METROPOLITAN GOVERNMENT OF NASHVILLE AND DAVIDSON COUNTY

STAFF RECOMMENDATION 1235 Fifth Avenue North May 21, 2014

Application: Demolition—outbuildings; New construction—infill
District: Germantown Historic Preservation Zoning Overlay
Council District: 19
Map and Parcel Numbers: 08209029200
Applicant: John Root, architect
Project Lead: Melissa Baldock, melissa.baldock@nashville.gov

Figure 6. The 1957 Sanborn map does not show the existing pergola and covered garden structure.

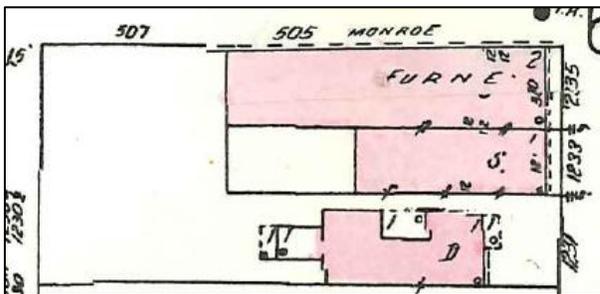
Demolition. The project requires the demolition of a fifteen foot by twenty-one foot (15' X 21') wooden pergola and a covered garden structure along Monroe Street (Figures 4 & 5). The dates of construction for the pergola and the covered garden structure are unknown, but the structures do not appear on the 1957 Sanborn map (Figure 6). It is likely that these structures were constructed in the mid-2000s. The two structures are not historic and do not contribute to the historical or architectural character and importance of the district. Staff therefore finds that their demolition meets guideline 7.0.

ARCHITECTURAL SITE PLAN

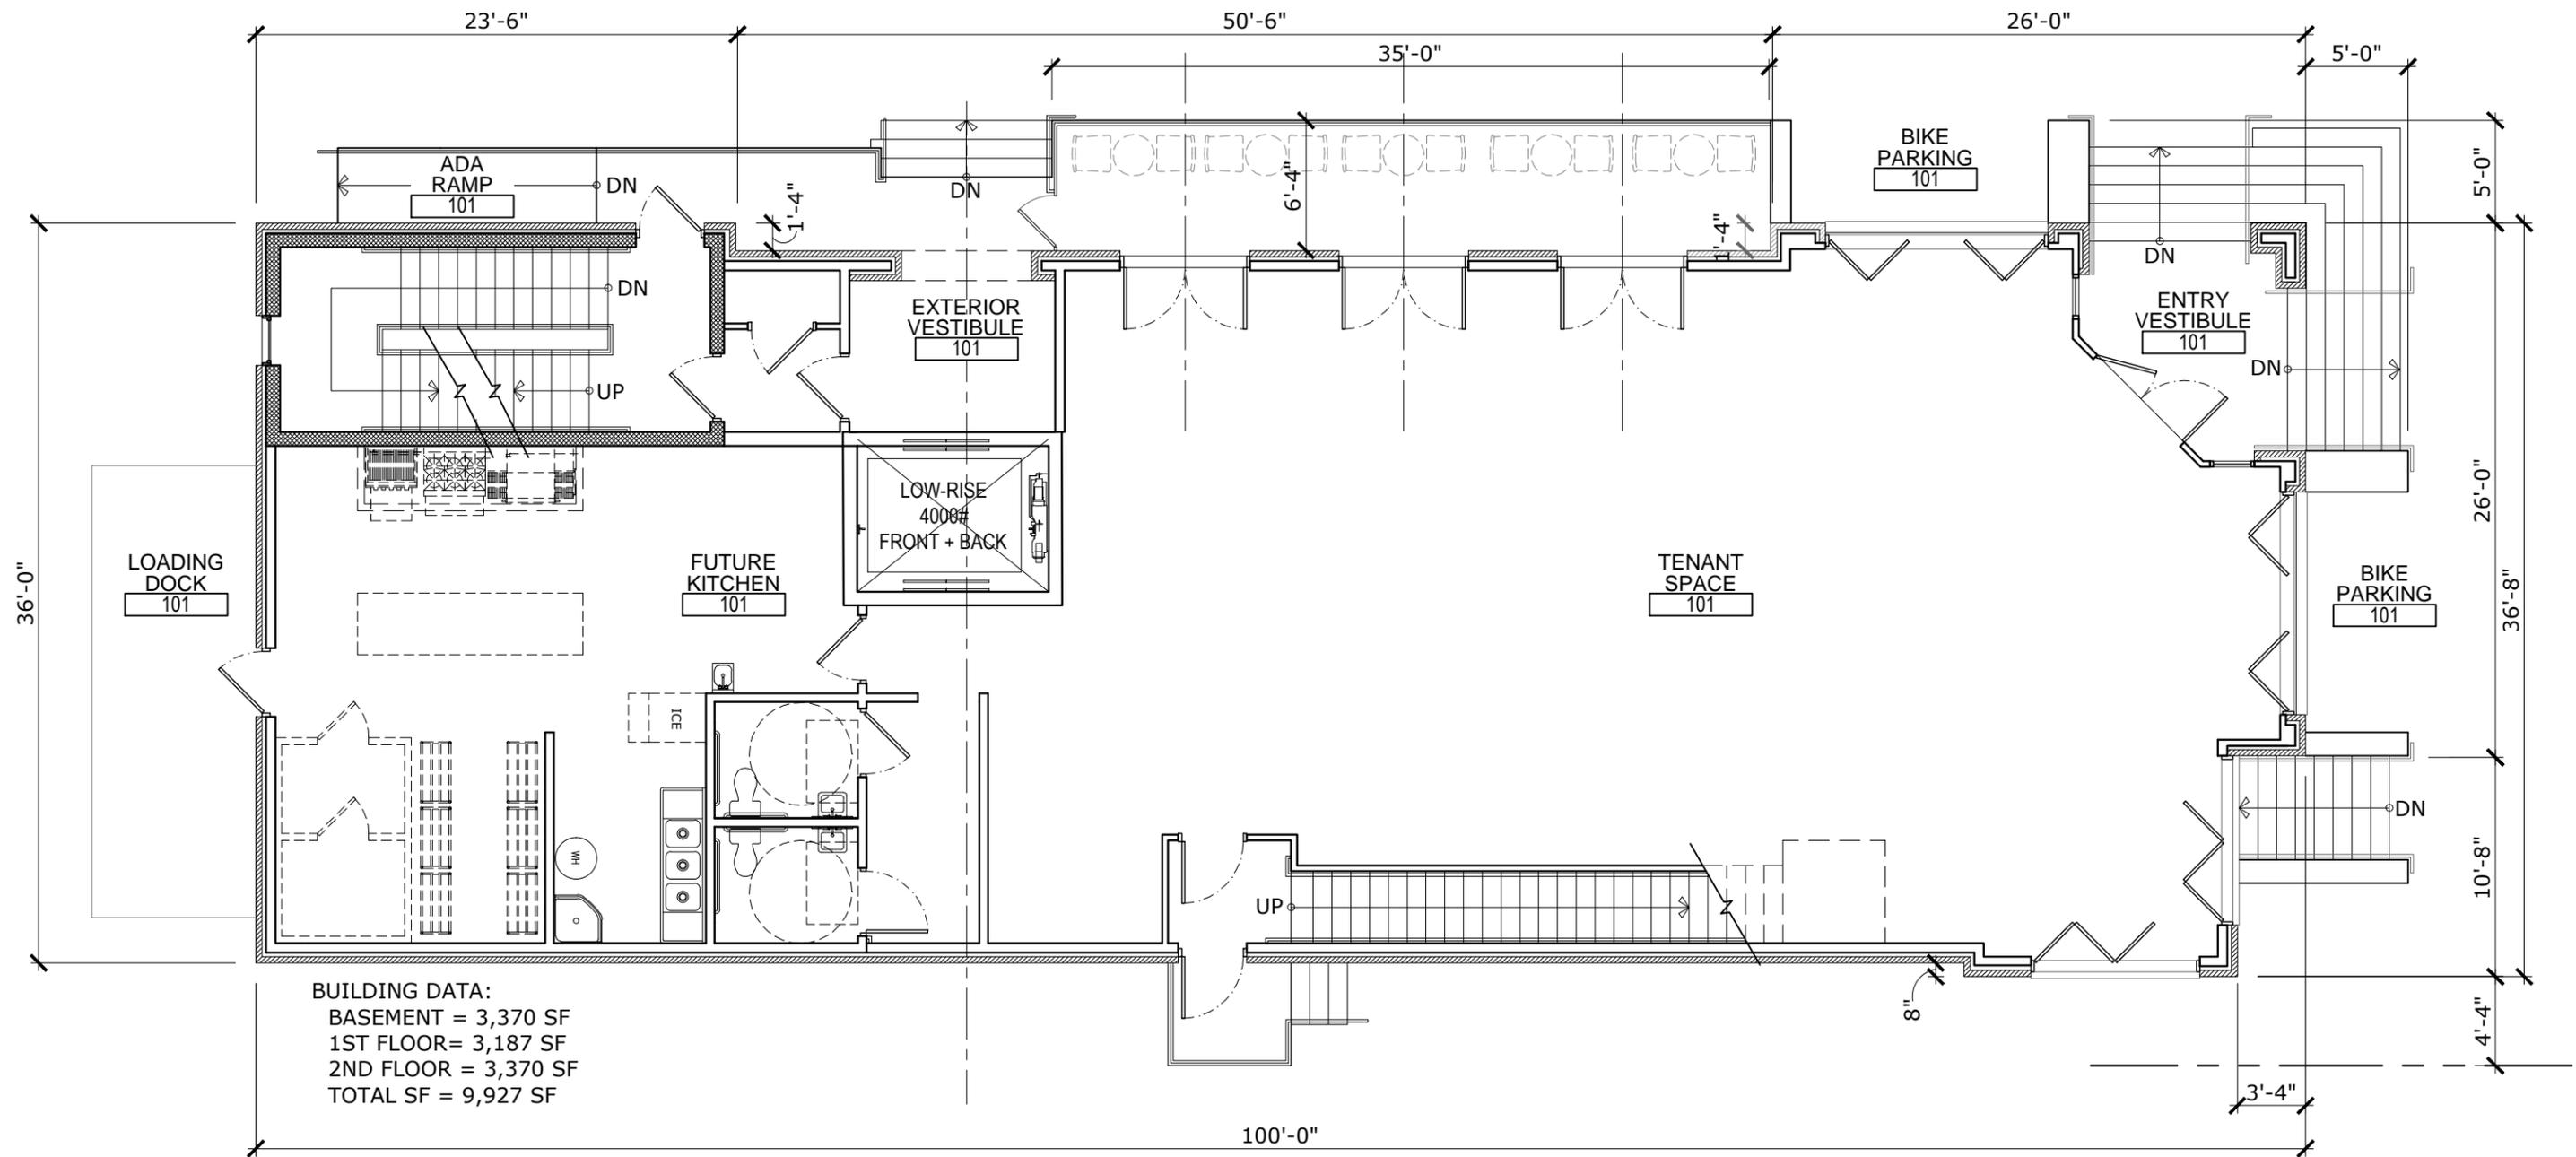
Utilities/Mechanical: The location of the utilities and the mechanical systems were not indicated on the site plan, and staff asks that they be located at the rear of the structure or on the roof.

Site Improvements/Appurtenances: No changes to the iconic brick Germantown sidewalks along Fifth Avenue North and Monroe Street were indicated on the plans. Parking for the structure will be located at the rear of the site. The parking will be accessed via the alley and via a new sixteen-foot (16’) wide curb cut along Monroe Street. The angle of the parking entrance along Monroe Street necessitates that it be wider than what the Commission typically requests. Staff finds that the proposed new curb cut is appropriate because it is located towards the back of the property, near the alley, and therefore it will have less impact on the streetscape. Staff asks to review the

paving material for the parking lot. Behind the new infill will be the trash and recycling dumpsters, surrounded by an enclosure. Staff asks to review the materials and design of the dumpster enclosure. No other fences and walls were indicated on the plans. Staff also asks to review all exterior lighting before it is installed. With the aforementioned staff reviews, staff finds that the proposed site improvements and appurtenances meet guideline 5.0.

1. Staff review a brick and a stone sample, the material for the basement stairs, and all window and door specifications;
2. HVAC units and other utilities be located at the rear of the structure or on the roof;
3. Staff review any new appurtenances, including all railings, the paving material for the parking area, the dumpster enclosure design and materials, any new fences or walls, and all exterior lighting fixtures.

EXTERIOR ELEVATIONS

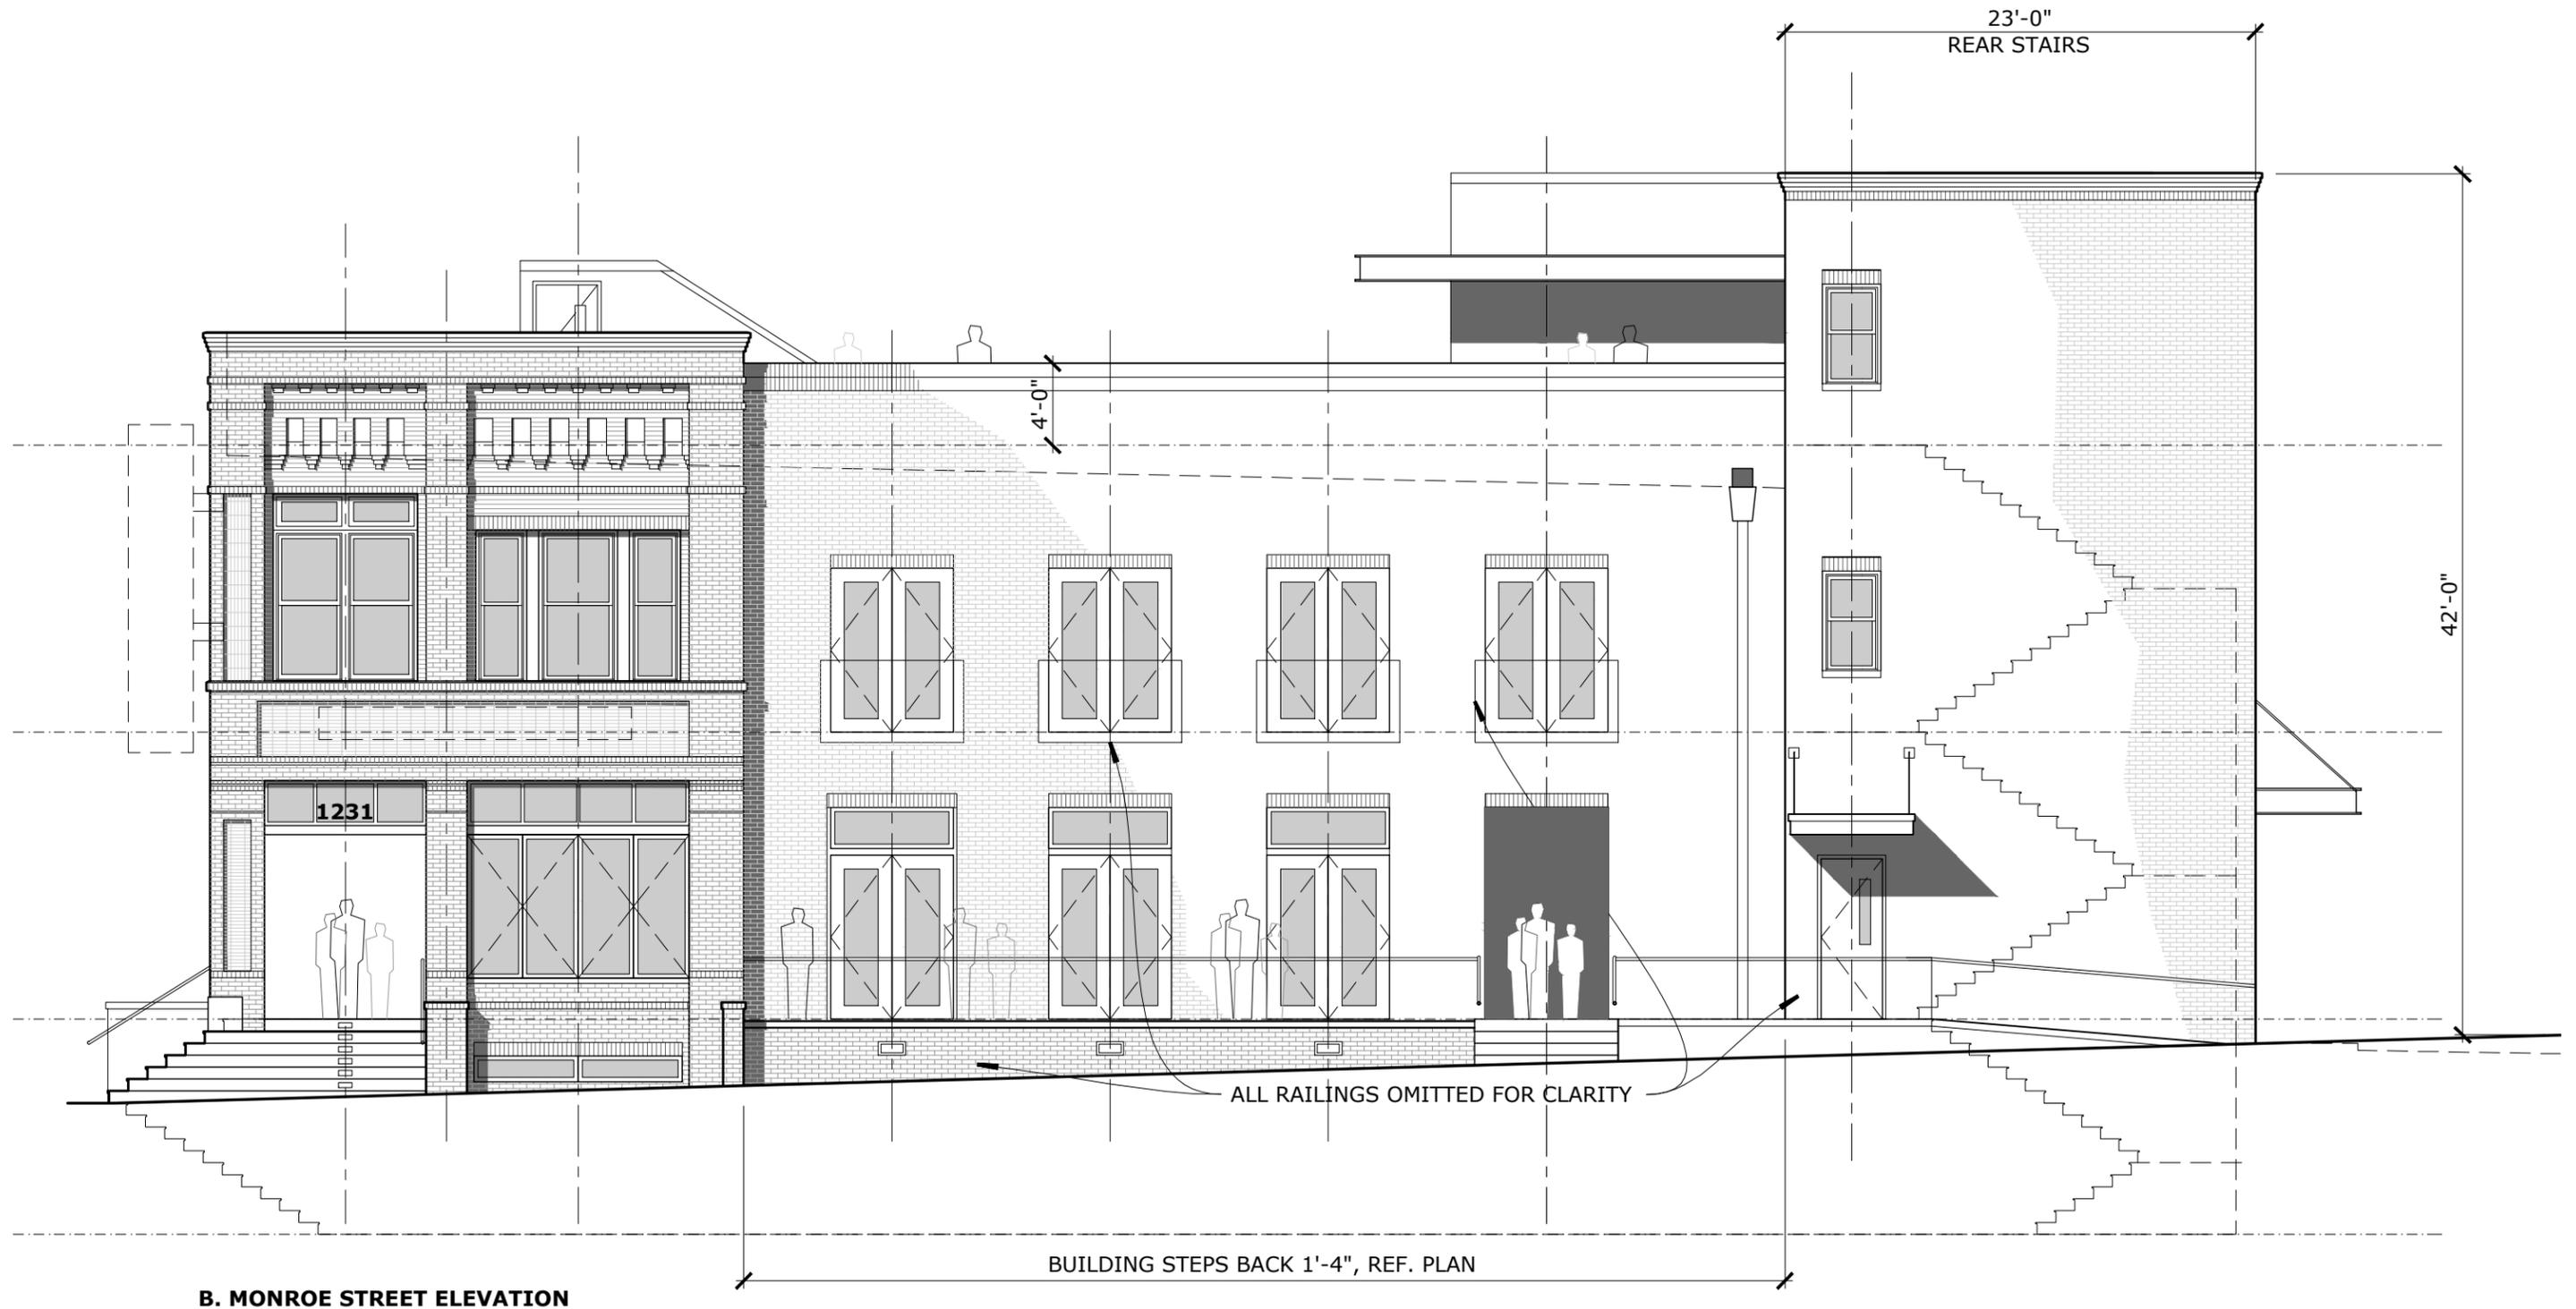
Orientation and Setbacks. The new infill will have a primary entrance at the corner of Fifth Avenue North and Monroe Street. The entrance will be chamfered and recessed at the ground floor, although the upper story is not chamfered, providing a cover for the entryway. Along Monroe Street there will be a recessed entry towards the rear of the structure and there will be a six foot (6') deep area for outdoor dining, accessed via three double storefront-type doors. The building will address both Fifth Avenue North and Monroe Street appropriately.

Foundation. The infill will have a four foot (4') tall foundation along Fifth Avenue North. This foundation height will decrease along Monroe Street as the site slopes upwards. The historic residential structures along the west side of Fifth Avenue North, adjacent to the site, also have foundations that are between three and four feet (3' – 4') tall (Figure 7). Staff therefore finds the foundation height to be appropriate. The foundation will be brick and will be delineated along the Fifth Avenue North façade with a soldier course and along Monroe Street with the handicap access ramp and platform for outdoor dining. Staff finds that the structure's proposed foundation meets guideline 2.3.

Materials. The primary exterior material will be brick, with extensive brick ornamental details along Fifth Avenue North and the front portion of the Monroe Street façade. Staff asks to review a brick sample. A cornerstone will be laid at the foundation level, and

staff asks to review a stone sample. The stairs leading to the corner entry will be concrete, and will have a metal railing. The material of the stairs leading to the basement was not indicated on the drawings, and staff asks to approve that material. The windows on the ground floor will be accordion bi-fold windows, while the windows on the upper floor will be double hung metal clad windows. At the top of the building will be continuous metal coping. The material for the roof will not be visible because the roof will be flat. The stair enclosure and the elevator bulkhead will be cementitious stucco. The canopy overhangs will be metal. The materials of the doors were not indicated, and staff asks to approve all windows and doors. Staff would also like to review the material and design of the railings for the balconies, dining platform area, and handicap access ramp. With the aforementioned final staff reviews of materials, staff finds that the proposed materials meet guideline 2.4.

Doors, Windows. The design of the main entry door at the corner is not visible on the plans because it is recessed and the one to the basement entrance is also not visible because it is below grade. Staff asks that the main entry door(s) be primarily glass and that the applicant submit a detail for the basement entry and main entrance prior to issuance of the permit. The other secondary doors are more utilitarian in design and are appropriate. The proposed window pattern along both Fifth Avenue North and Monroe Street matches the historic context. There are no large expanses without a window or door opening, with the exception of the interior façade that will be minimally visible from the public right-of-way. The windows on the second story are no taller than those on the ground floor and the windows are all vertically oriented. On the Monroe Street façade, there are four second-story doorways with shallow “Juliet” balconies. The balconies are no more than one foot, four inches (1’4”) deep, and because they are so shallow, staff finds that they are appropriate. Modestly scaled balconies were recently approved by the Commission for a multi-use project at the corner of Sixth Avenue North and Taylor Street. Staff finds that the infill’s doors and windows will meet guidelines 2.5 and 2.6.
